## **Quality Control Report**

Consultant Wahib Medanat Consultant Engineers Rep No. QC-11 07

Site Name Um Al Dananir Basic Mixed - Balqa Date 15 / 06 / 2021

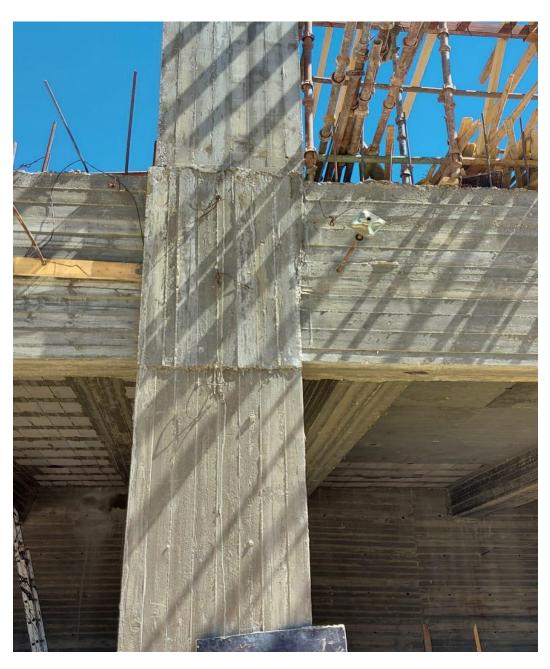
Description of Non Conformance	Corrective Action	Required by / When
In some locations, walls, columns and roof external beams are not in line together. Teething were observed. The teething is expected to be within the space allocated for building stones.	Chipping is needed for limiteed locations.	The Contractor/Immediately
Report Prepared by	Hassan Shaqbua, Supervision Quality Control Manager	-
